**Submission of Layout Plan and Application for Commercial Development on IL No.8945 Causeway Bay, Hong Kong  
under s16 of the Town Planning Ordinance (Cap.131)**

**s.16 Planning Application No. A/H7/185 - Departmental Comments**

**Response to Comments**

April 2024

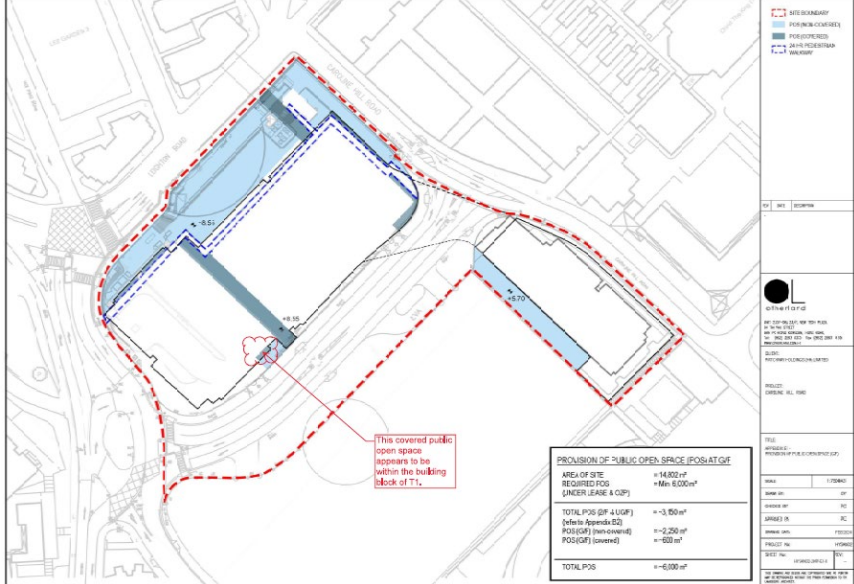
<p>42. Appendix E1 - A small portion of public covered open space at G/F appears to be within the building block of T1 (see attached mark-up), which is not a countable open space. The applicant's response in the R-to-C table "For the mentioned POS at G/F, although it is covered by covered landscape bridge but not within the building block of T1, a bench will be placed there as a recreational function" is not addressing our previous comment. Please clarify.</p>	<p>Please note that building outline of G/F is supplemented in Appendix E1 of LMP, to demonstrate the mentioned covered open space at G/F is not within the building block of T1.</p>																
<p>[See attachment "Markup(Covered POS at T1).pdf"]</p>
